Access Compliance Report

Public Rights-of-Way

(Curb Ramps)

| Intersection ID: 42559 | Main Street: ENEIDA_SUE_DR | Cross Street: LUNDY_LN | Location: | N |

| ADA ID: BF7DF3571972 | Ramp Type: Perp | Initial Pass/Fail: Fail | Overall Compliance: No | Severity Score: 10 |

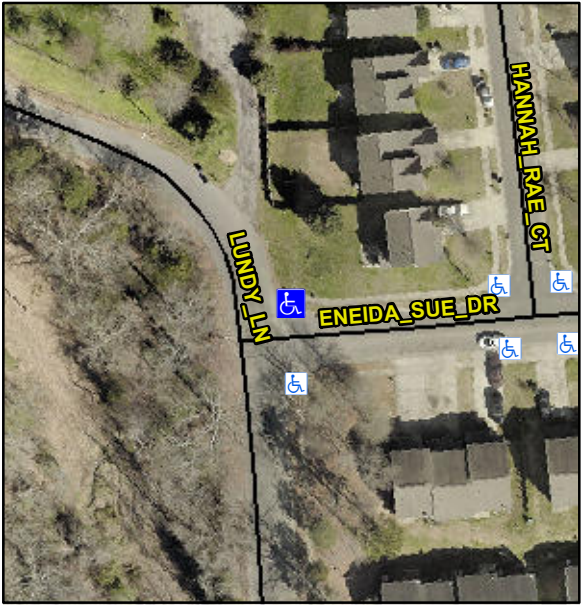
| Codes/Mitigation Info/Possible Solution | | | Field Measurements/Component Compliance | | |
|--|-------------------------------|--|---|-----------------------------|-------------|
| | | | No | Ramp Width (in) | 41.0 |
| <p>Surveyor Notes:</p> <p>N/A</p> <p>PROW/ADA:</p> <p>R304.5.1, R304.5.3</p> | | | N/A | Flare Type RT | N/A |
| | | | N/A | Gutter Ponding? | Yes |

| Codes/Mitigation Info/Possible Solution | | | Field Measurements/Component Compliance | | |
|--|-------------------------------|--|---|-----------------------------|-------------|
| | Remove & Replace Entire Ramp. | | N/A | Ramp Length (in) | 48.5 |
